ENGINEERING CHANGE NOTICE

Proj. ECN B-714-24

BLOCK 5: B-714, GROUT VAULT PAIR (218-E-16-102 & 103) (218-E-16-104 & 105) / ER8007
BLOCK 6: 218-E-16-102 & -103 and 218-E-16-104 & -105
BLOCK 9: ECN B-714-7, -9, -10, -15, -19, -20
BLOCK 8: SPECIFICATION B-714-C2, ~~REV 0~~ 2-7-90 (V-B714C2-003, REV 0) SEE PAGE 9 & 10

VAULTS 218-E-16-102 & 103
CIVIL/STRUCTURAL CHANGES TO DRAWINGS

Ref. Dwg. ECN B-714-19	Sh. 14	Rev. 0	Prepared By STAN SMITH	Checked By	ECN No. B-714-24

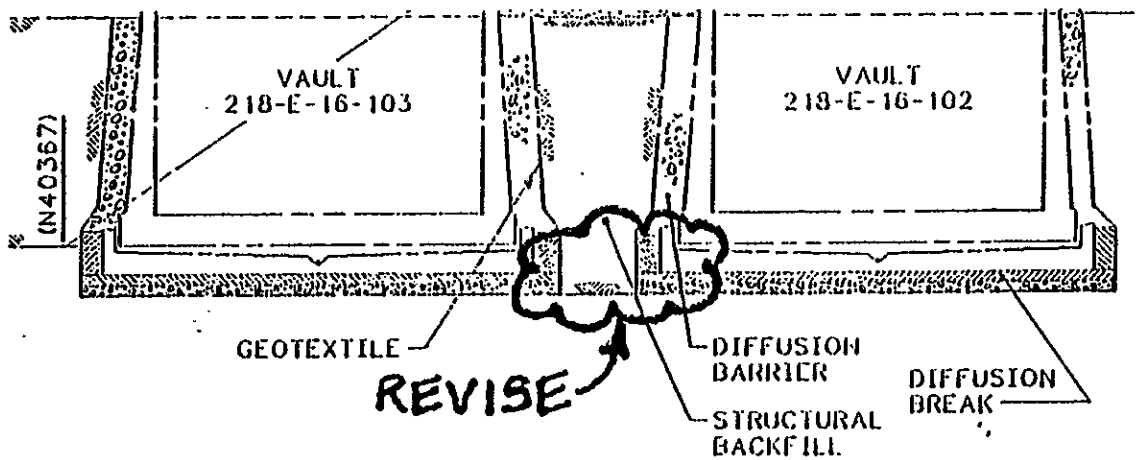
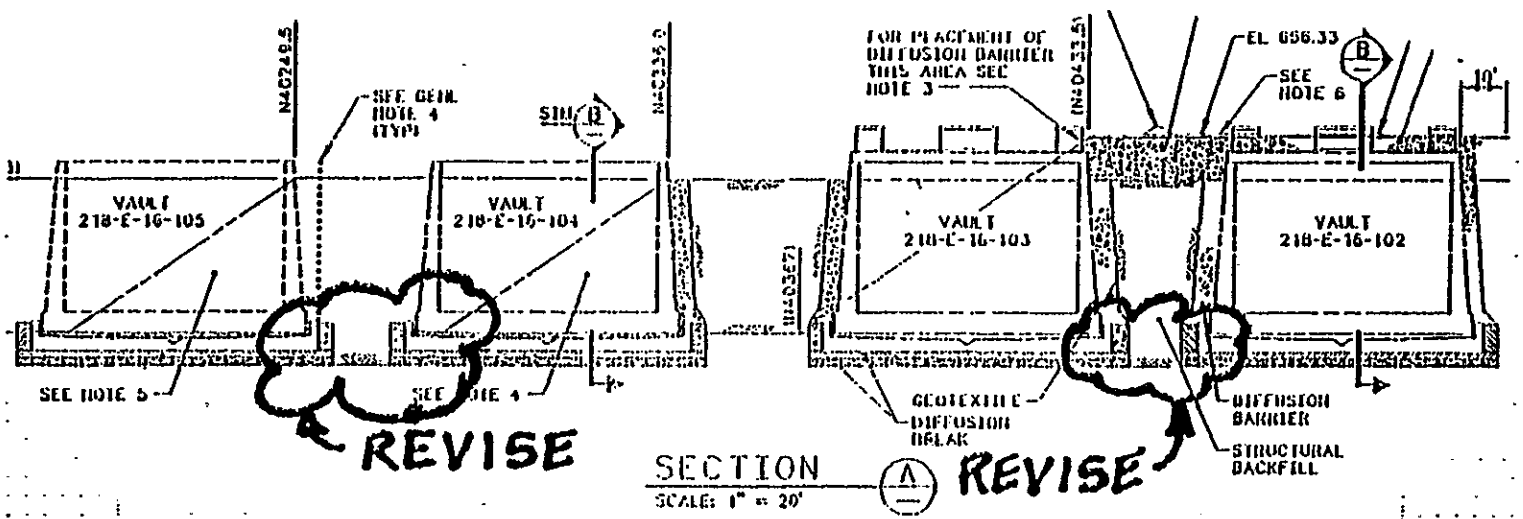
28) ECN B-714-19, PAGE 10, 13 & 14
A) Modify SECTION D - see page 19 of this ECN.
(Ref: H-2-77575, SH 2, REV 1)
B) Modify SECTION D - see page 19 of this ECN.
(Ref: H-2-77576, SH 1, REV 0)
C) Modify SECTION A - see page 20 of this ECN.
(Ref: H-2-77578, SH 1, REV 0)

54) ECN B-714-19, PAGE 10, 13 & 14
A) Modify SECTION D - see page 19 of this ECN.
(Ref: H-2-78446, SH 2, REV 0)
B) Modify SECTION D - see page 19 of this ECN.
(Ref: H-2-78447, SH 1, REV 0)
C) Modify SECTION A - see page 20 of this ECN.
(Ref: H-2-78448, SH 1, REV 0)

KAISER ENGINEERS HANFORD			ENGINEERING CHANGE NOTICE SKETCH			
Ref. Cwg.	Sh.	Rev.	Prepared By	Checked By	ECN No.	Page
H-2-77618	4	0	TK EHRHARD	PC Barrows	B-714-24	22/28
H-2-77618	12	0				
H-2-78490	4	0				
H-2-78490	12	0

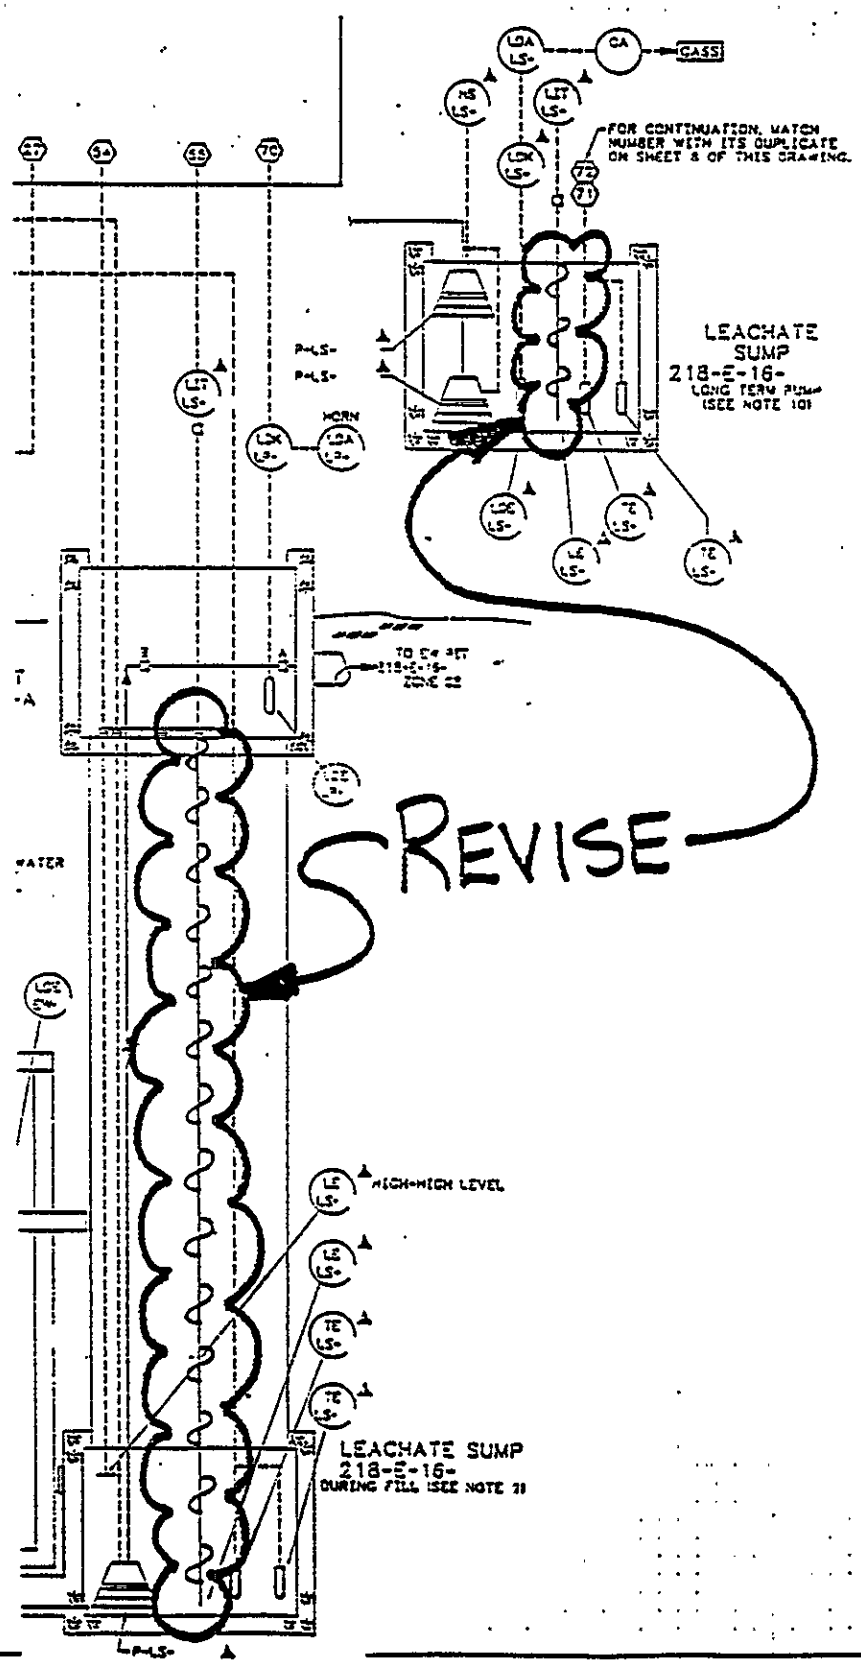
15) H-2-77618, SH 4, REV 0
Change LEACHATE SUMPS as shown on page 22 of this ECN.

16) H-2-77618, SH 12, REV 0
Change LEACHATE SUMPS as shown on page 22 of this ECN.

42) H-2-78490, SH 4, REV 0
Change LEACHATE SUMPS (ZE-F1, A-D2) as shown on page 22 of this ECN.

43) H-2-78490, SH 12, REV 0
Change LEACHATE SUMPS (ZE-F1, A-D2) as shown on page 22 of this ECN.

KAISER ENGINEERS HANFORD	ENGINEERING CHANGE NOTICE SKETCH					
Ref. Dwg. H-2-77636	Sh. 2	Rev. 0	Prepared By G. KUBINSKI	Checked By	ECN No. B-714-24	Page 23/28

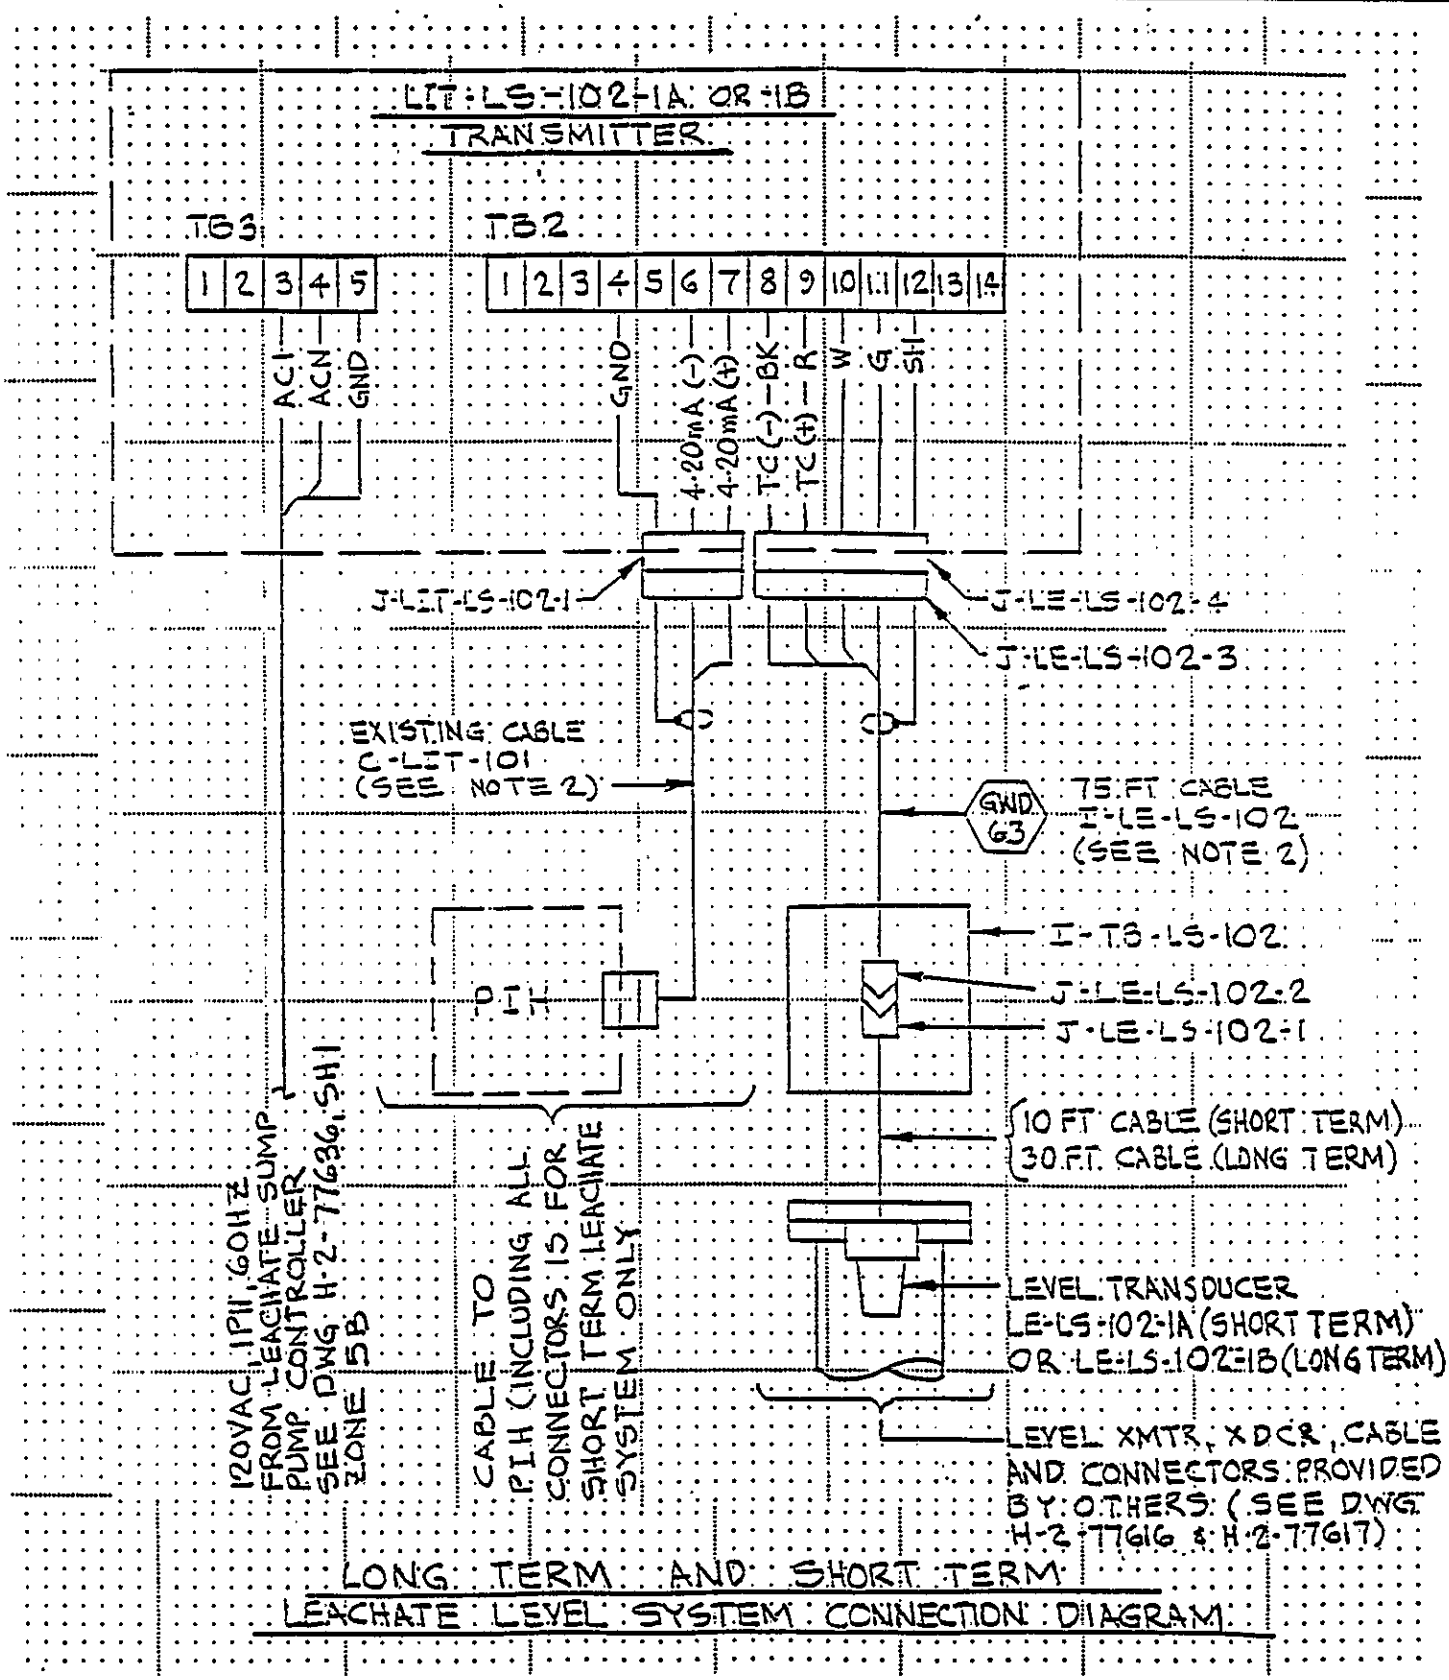
18) H-2-77636, SH 2, REV 0
Add CONNECTION DIAGRAM as shown on page 23 of this ECN.

KAISER ENGINEERS HANFORD	ENGINEERING CHANGE NOTICE SKETCH					
Ref. Dwg.	Sh.	Rev.	Prepared By	Checked By	ECN No.	Page
H-2-77636	4	0	G. KUBINSKI	A. R. Snowden	B-714-24	24/28

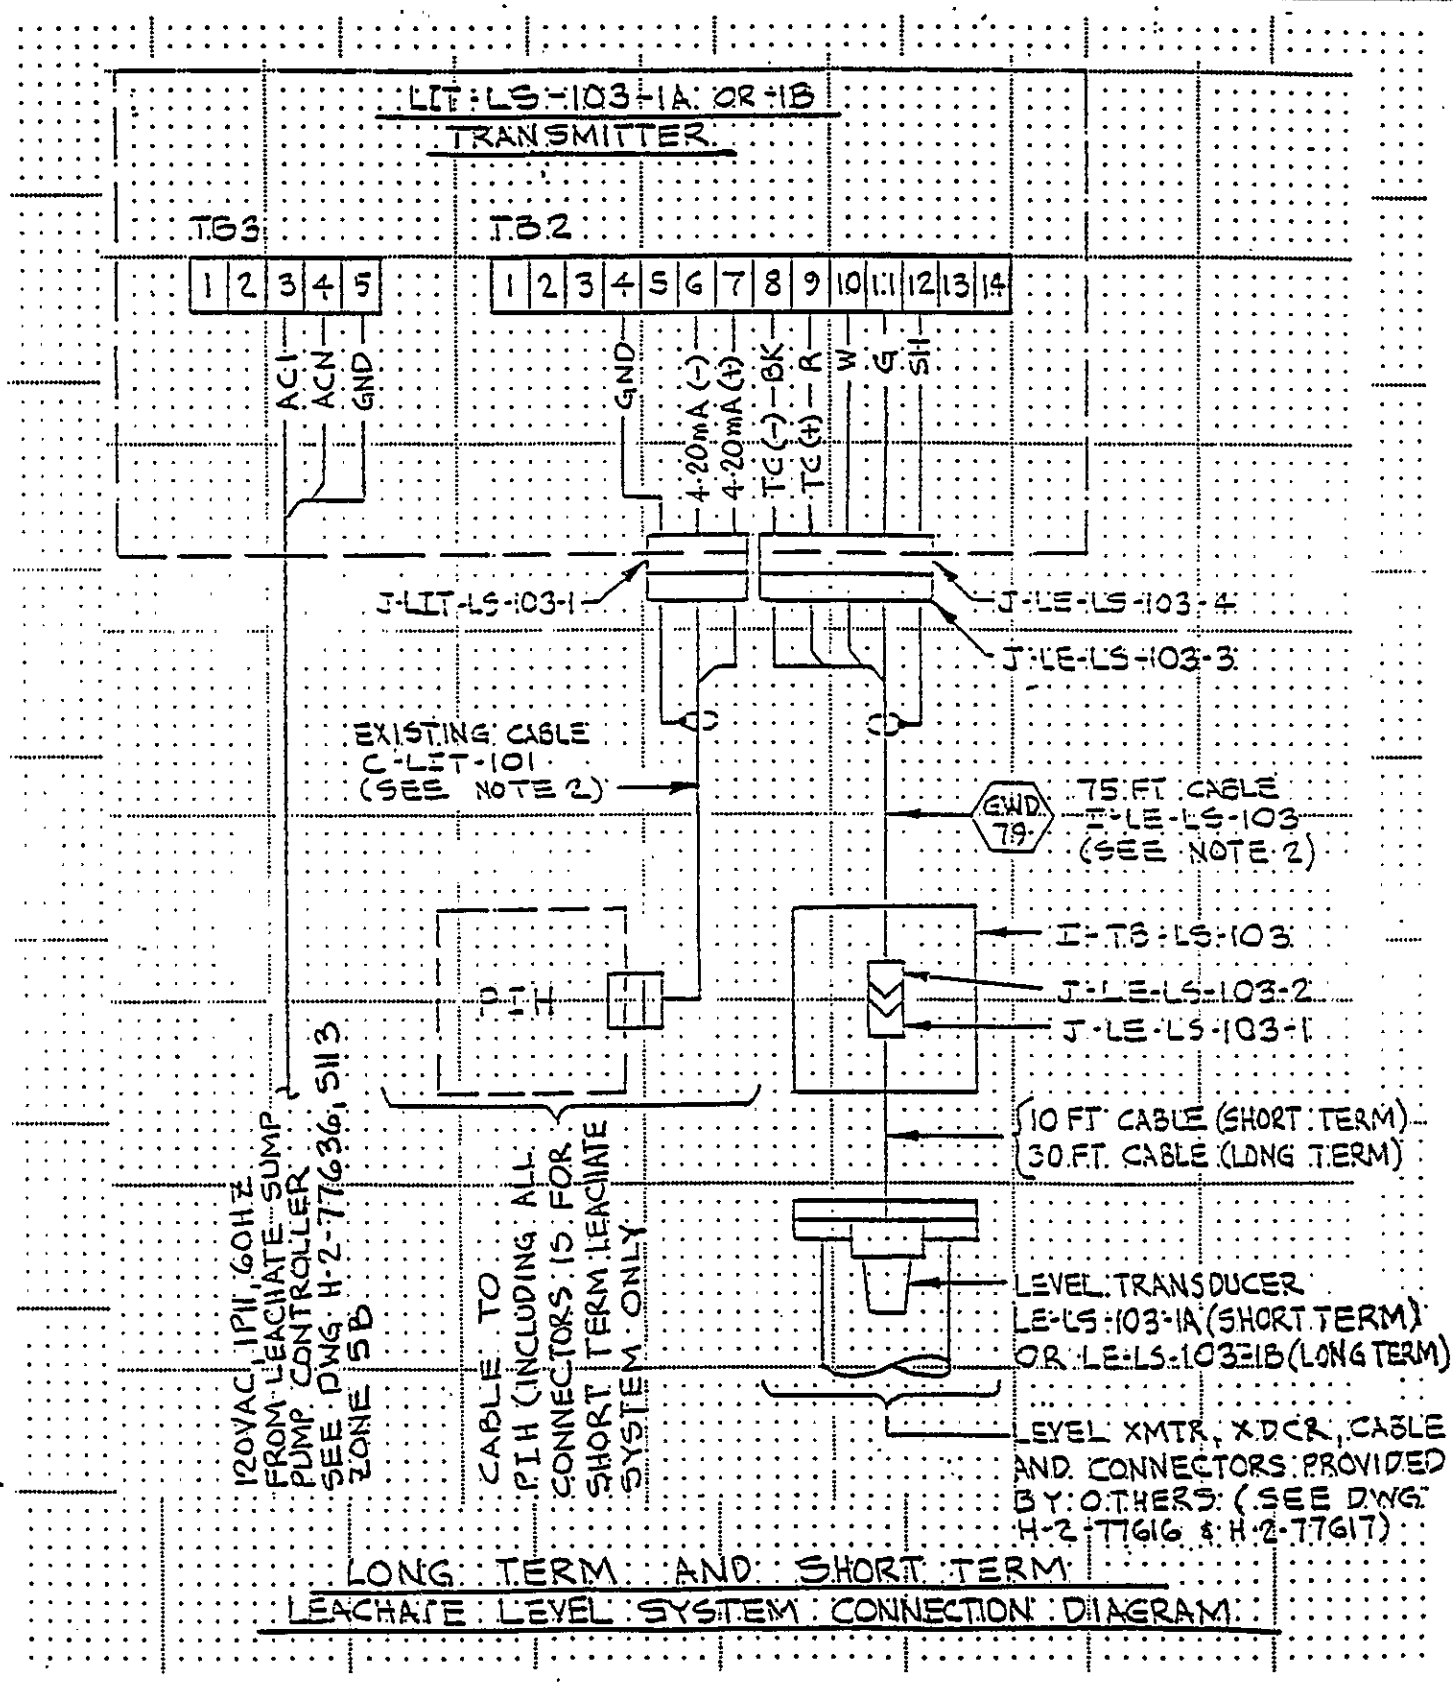
20) H-2-77636, SH 4, REV 0
Add CONNECTION DIAGRAM as shown on page 24 of this ECN.

KAISER ENGINEERS HANFORD	ENGINEERING CHANGE NOTICE SKETCH					
Ref. Dwg. H-2-78502	Sh. 2	Rev. 0	Prepared By G. KUBINSKI	Checked By	ECN No. B-714-24	Page 26/28

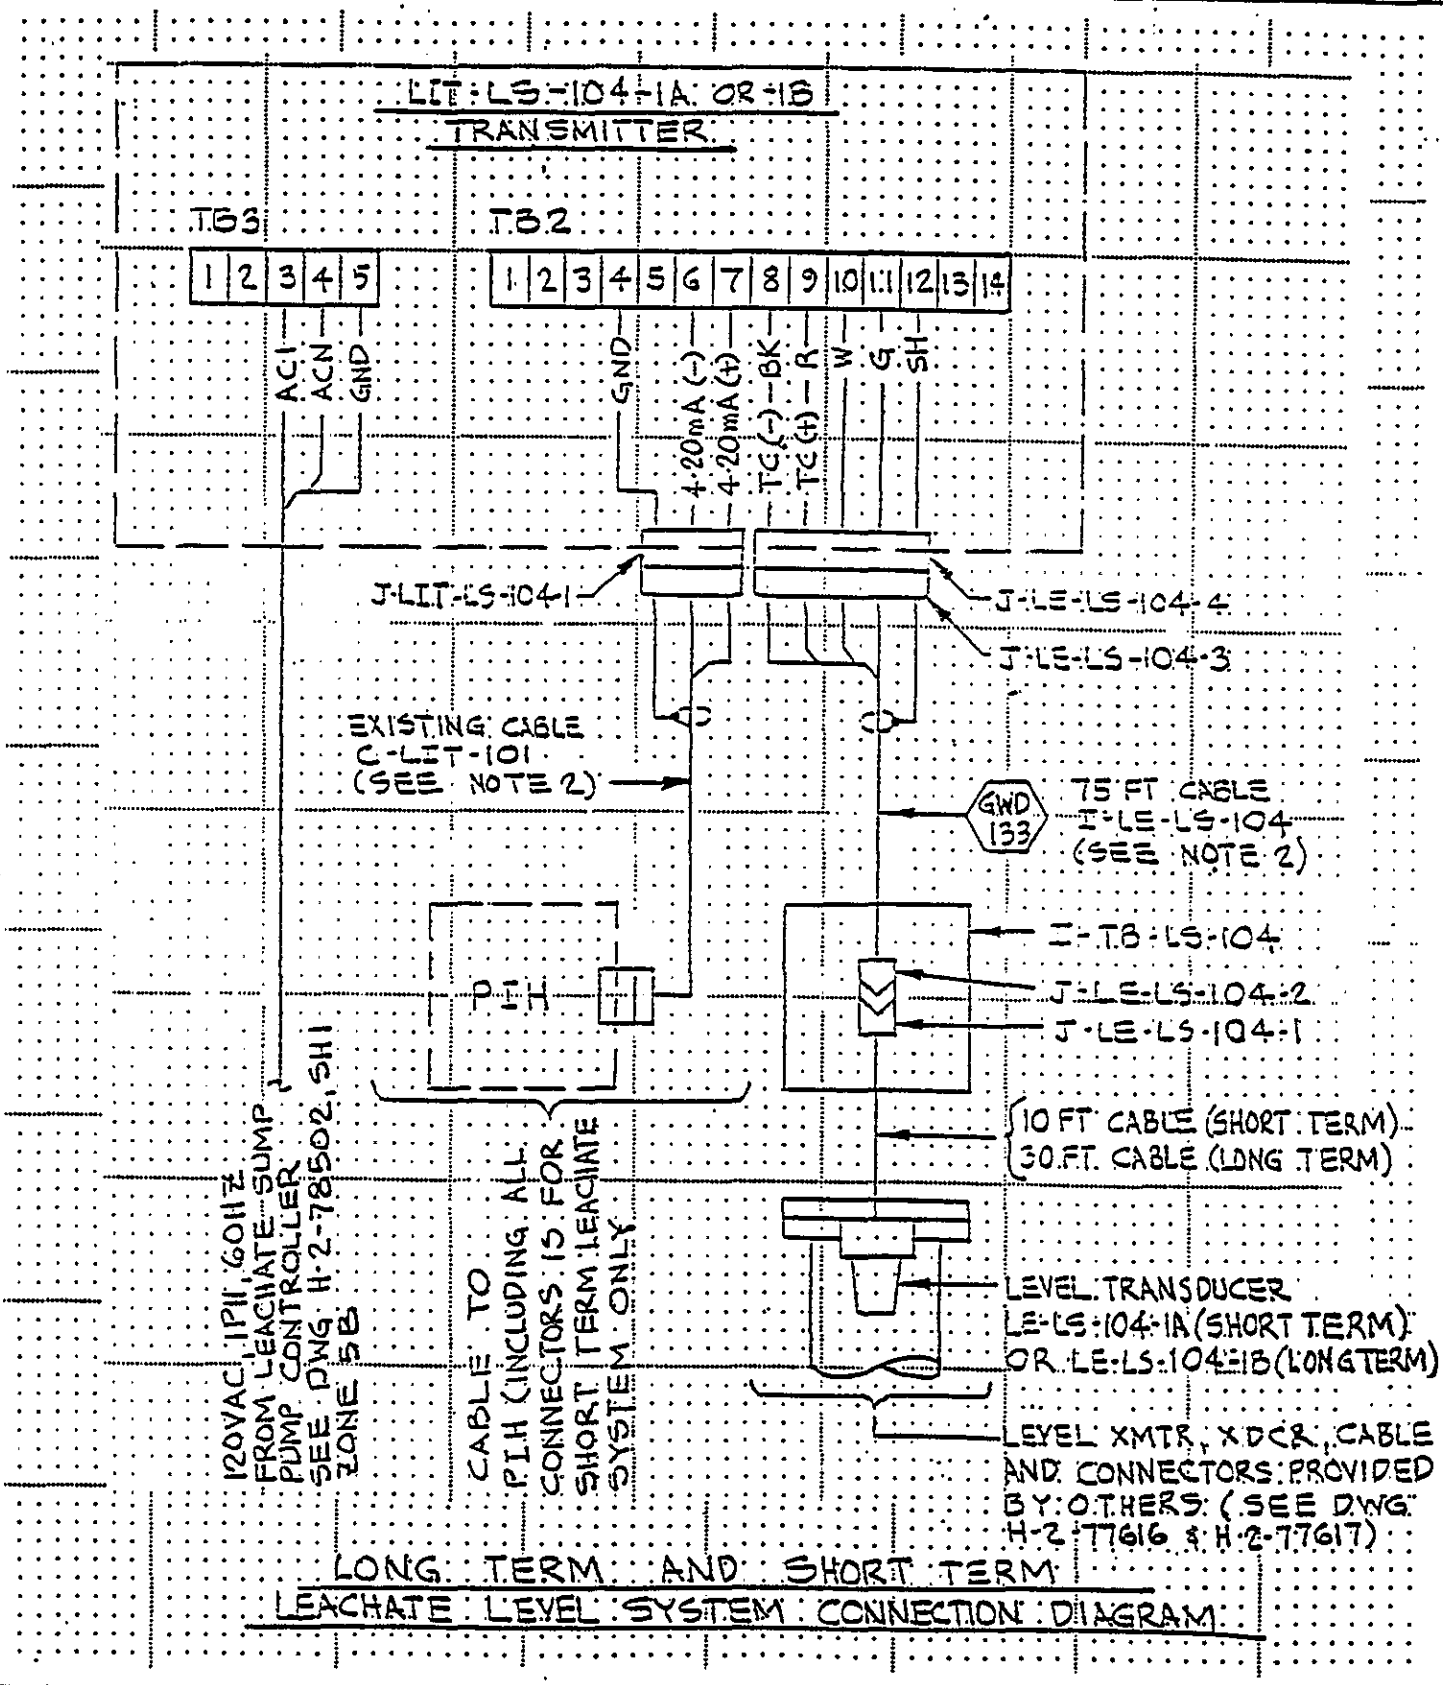
45) H-2-78502, SH 2, REV 0
Add CONNECTION DIAGRAM as shown on page 26 of this ECN.
